Access Compliance Report

Public Rights-of-Way

(Curb Ramps)

Intersection ID: 31227	Main Street: CLACKWYCK_LN	Cross Street: HEADQUARTERS_FARM_RD	Location: E
ADA ID: F892EEEB1B18	Ramp Type: Perp	Initial Pass/Fail: Fail	Overall Compliance: No
Severity Score: 17.5			
Codes/Mitigation Info/Possible Solution		Field Measurements/Component Compliance

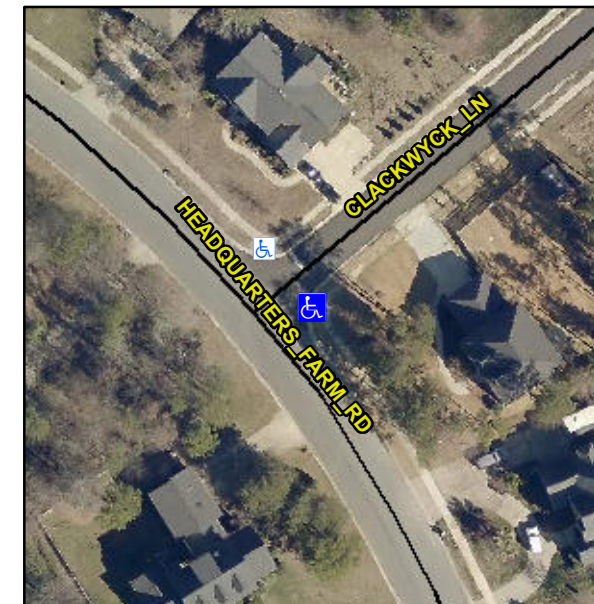
Not Found, R304.5.1

Compliance	Description	Data	Compliance	Description	Data
N/A	Ramp Length (in)	62.0	Yes	Ramp Slope (%)	5.0
No	Ramp Width (in)	35.0	Yes	Ramp XSlope (%)	0.6
N/A	Flare Type LT	N/A	N/A	Flare Type RT	N/A
N/A	Flare Slope LT (%)	N/A	N/A	Flare Slope RT (%)	N/A
N/A	Flare Traversable LT?	N/A	N/A	Flare Traversable RT?	N/A
N/A	Landing Length (in)	N/A	N/A	DWS Provided?	N/A
N/A	Landing Width (in)	N/A	N/A	DWS Contrast?	N/A
N/A	Landing Slope (%)	N/A	N/A	DWS Length (in)	N/A
N/A	Landing X Slope (%)	N/A	N/A	DWS Full Width?	N/A
N/A	Landing Curb? (Y/N)	N/A	N/A	DWS Offset (in)	N/A
N/A	Shared Landing?	N/A			
N/A	Gutter Ponding?	N/A	N/A	Gutter Slope (%)	N/A
N/A	Gutter Lip Ht (in)	N/A	N/A	Gutter X Slope (%)	N/A
N/A	Painted X Walk1?	No	N/A	Painted X Walk2?	N/A
	X Walk 1 Direction	To NW		X Walk 2 Direction	N/A
N/A	X Walk 1 Width (in)	N/A	N/A	X Walk 2 Width (in)	N/A
	X Walk 1 Slope (%)	6.1		X Walk 2 Slope (%)	N/A
	X Walk 1 X Slope (%)	1.3		X Walk 2 X Slope (%)	N/A

Remove & Replace Entire Ramp.
